# Work Order ID 108695

Item Name: Crosstube Turning Detail

DRAWING NO. D212-664-141	TITLE XTUBE ASSY (205/212/412 HI FWD)	REV. D	DART AEROSPACE LTD ENGINEERING ORDER		D.E.O. NO. D212-664-141-D-1	SHEET NO. SHEET 1 OF 2	SCALE NTS
DRAWN	CHECKED	MP	MFG. APPR.	APPROVED	MP	DE APPR.	
DATE 11.04.07	DATE 11.04.11		DATE 11.04.12	DATE 11/04/12		DATE 11.04.12

DRAWING NO. D212-664-141	TITLE CROSSTUBE ASS'Y (205 HI FWD)	REV. D	<b>DART AEROSPACE LTD ENGINEERING ORDER</b>		D.E.O. NO. D212-664-141-D-2	SHEET NO. SHEET 1 OF 1	SCALE NTS
DRAWN <i>UP</i>	CHECKED <i>ADS</i>	MFG. APPR. <i>EB</i>	APPROVED <i>MD</i>		DE APPR. <i>TH</i>		
DATE 11.07.15	DATE 11.07.20	DATE 11.07.21	DATE 11/07/21		DATE 11.07.21

**D212-664-141/-141B  
ASSEMBLY DETAIL**

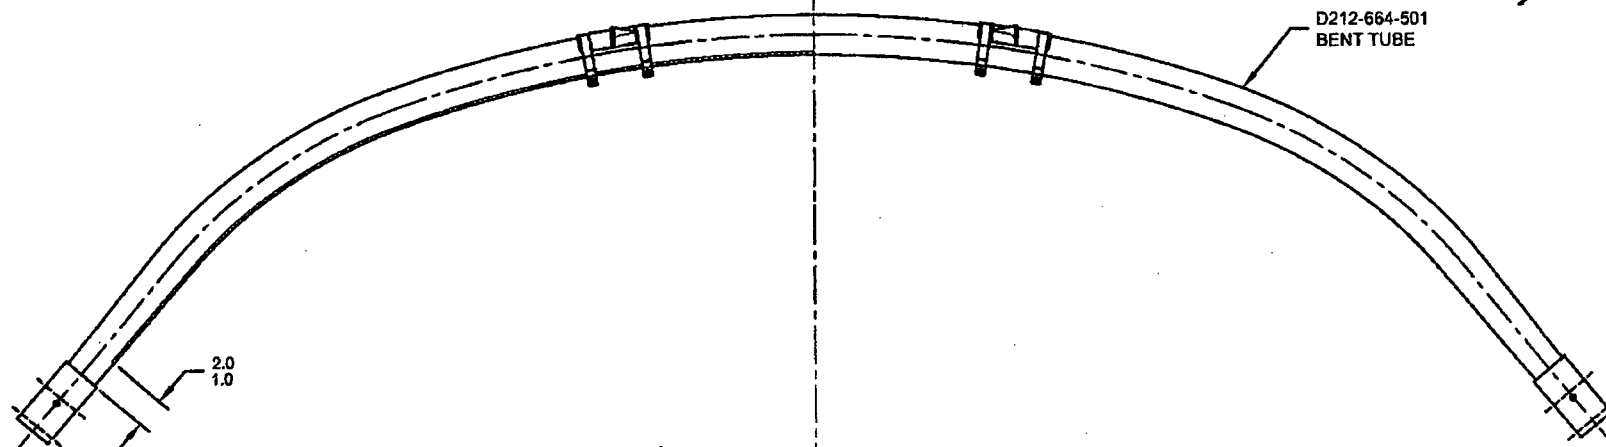
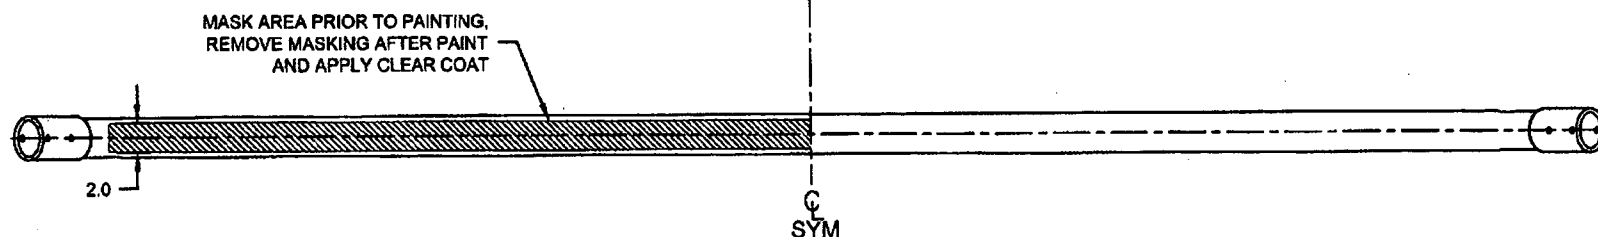
**PURPOSE:**

ADD AN INSPECTION WINDOW TO UNDERSIDE OF CROSSTUBE.

**CHANGE:**

NOTES 2 OF SHEET 1 IS AMENDED AS FOLLOWS:

**IS:**

**WAS:**

- 2) FINISH: CHEMICAL CONVERSION COAT PER DART QSI 005 4.1  
PRIME INSIDE AND OUTSIDE PER DART QSI 005 4.2  
PAINT OUTSIDE PER DART QSI 005 4.2

- 2) FINISH: CHEMICAL CONVERSION COAT PER DART QSI 005 4.1  
PRIME INSIDE AND OUTSIDE PER DART QSI 005 4.2  
MASK UNDERSIDE OF CROSSTUBE AS SHOWN (HATCHED AREA) AND  
PAINT OUTSIDE PER DART QSI 005 4.2  
REMOVE MASKING AND APPLY CLEAR COAT

IS:

WAS:
